Staff Report to the Planning Commission

April 9, 2025

PSC2023-0001, PTP2025-0005, PWEP2025-0002 and PNFMSM2025-0002

Oak Creek Condominiums

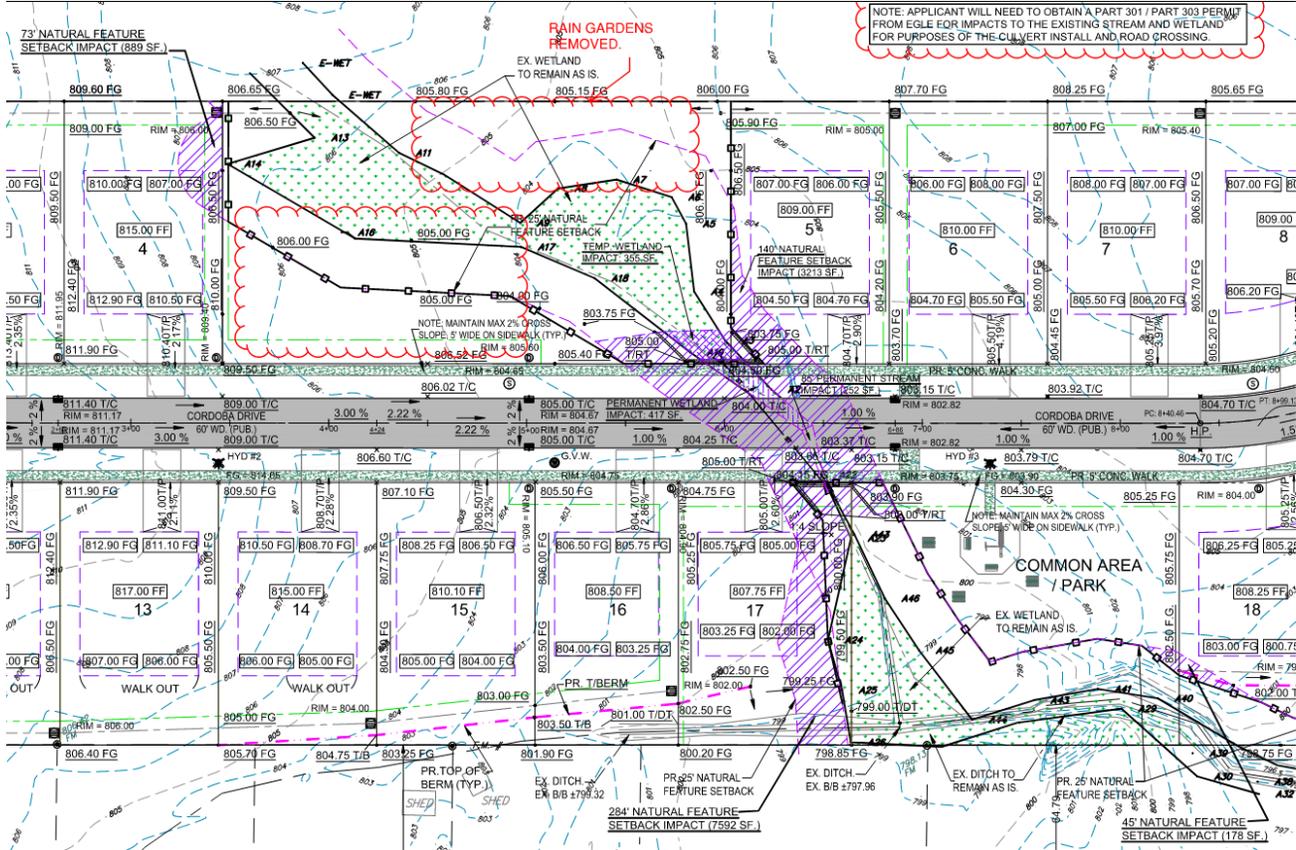
The site plan also proposes several small areas of natural features modification. The first is located on the east side of Unit #4 on the north side of Cardoba Drive. The wetland in this area is not proposed to be impacted, just the natural feature setback. The proposed modification will provide a unit configuration that is squared off, in typical unit configuration. As noted in the ASTI review, the natural feature setback area is of low quality.

Second, the natural feature setback along the eastern side of unit #17 will also be impacted. The natural feature setback is of a low to medium quality in this area. This is the largest impact as a result of lot configuration. Portions of the natural features setback will be reduced to 0 feet along the edge of the wetland, however, at least a small portion of the natural feature setback will be maintained in most areas. As noted below, a split rail fence will be provided between the remaining natural features setback area or wetland area as the case may be and the private yard space of unit #17, as a physical barrier and reminder of the importance of these areas.

The third proposed modification area is along unit #18. Only a small portion of the natural feature setback is proposed to be impacted in this location, to provide a uniform building envelope area. The natural feature setback area associated with unit#18 is considered to be high quality.

Fourth, a small portion of the natural feature setback will be modified along the southwest portion of unit #5. This impact is largely a result of the filling and modification of the wetland request to construct the road but these activities will carry into the unit area of unit #5. The quality of this area of natural feature setback is higher than in most areas of the site and ASTI recommends minimizing the disturbance to these natural areas.

Finally, the natural feature setback in the location of the roadway construction will also be impacted. The natural feature setback in this area is of a low quality and function. The proposed crossing occurs in an area where the natural feature setback will be impacted in this least possible manner.

Applicable to all of the proposed areas where natural feature setbacks abut the proposed development of the roadway and associated lots, a split rail fence will be used to provide delineation along the required natural features setback which traverses both sides of the drain/wetland area that runs north/south through the site. In addition, the site plan notes that signage will be installed prohibiting the mowing, use of chemicals, etc. in these areas in order to maintain the integrity of the wetlands and natural features setback areas as much as is possible.
